ADDENDUM 1

DATE: October 18, 2017

Contract 17-C-00029; Robles Park Pump Station Replacement

SHEET
C-14
OF 65

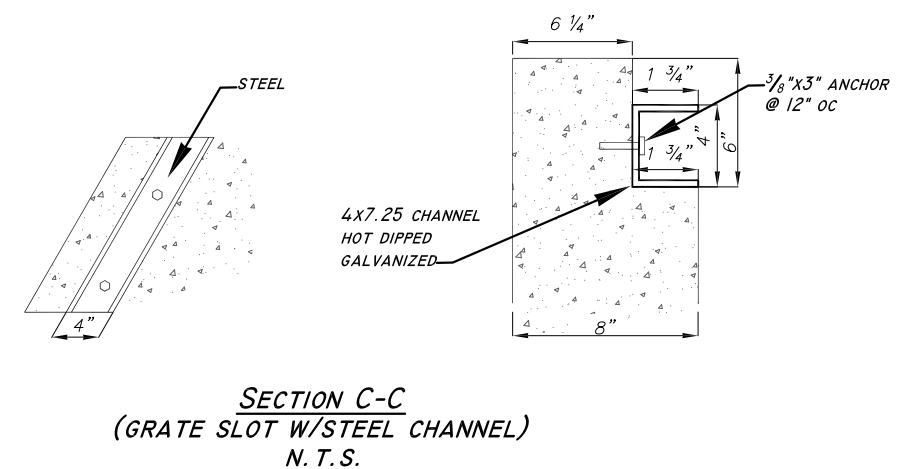
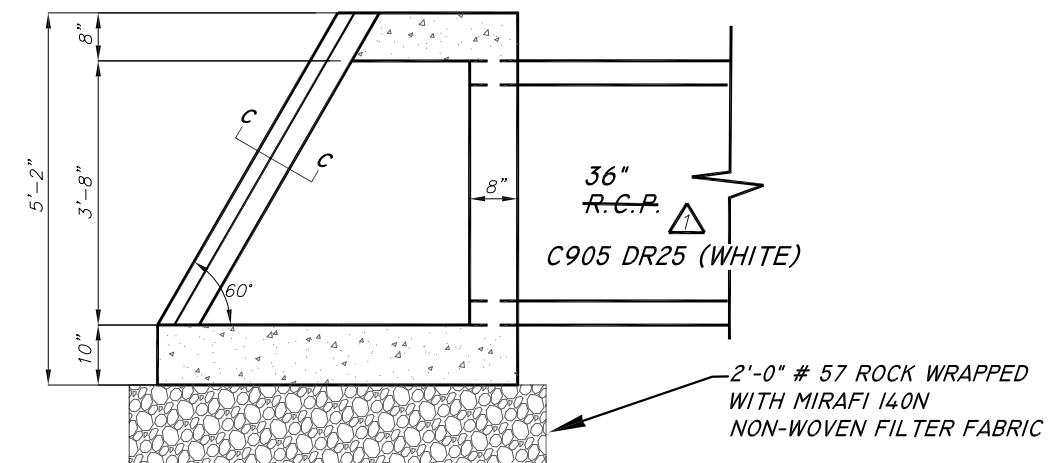
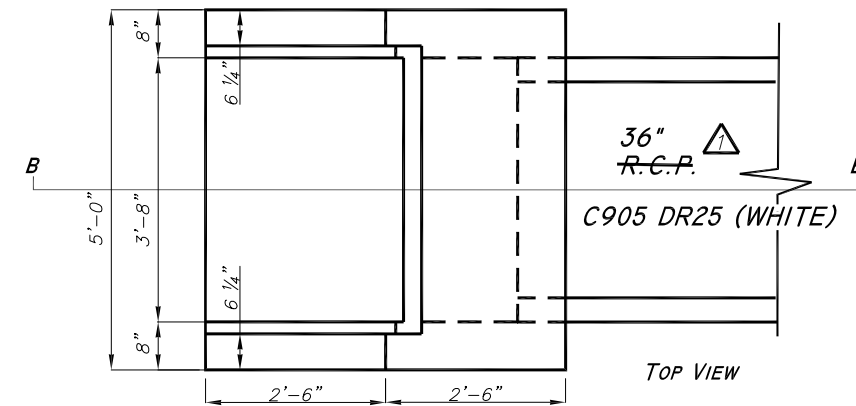
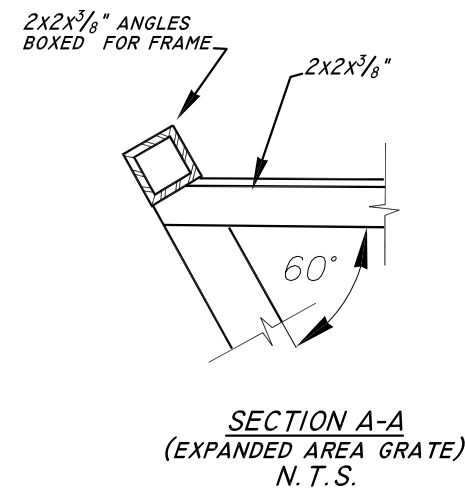
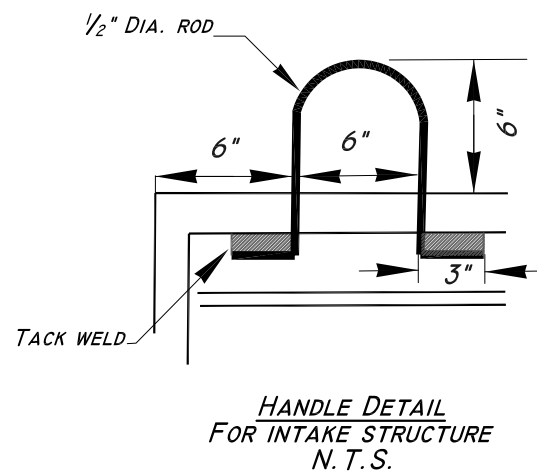
- Item 1: Insert, after page 2 of the U-WMBE Contact List, the attached MBD-70 form.
- Item 2: Replace Proposal pages P-2 thru P-5 with the attached Proposal pages P-2R thru P-5R.
- Item 3: Contract Item 334-5 Stabilized Sub-Base shall include the cost of excavating and removal of soil necessary to accommodate the installation of base and leveling sand.
- Item 4: Replace plan sheet C-14 with the attached plan sheet C-14. Revision includes correcting the intake pipe from RCP to C905 DR 25 PVC pipe.
- Item 5: Attached for reference is the pre-bid meeting sign-in sheet.

No.	DATE	REVISIONS
3		
2		
1	10/11/17	CORRECTED PIPE MATERIAL
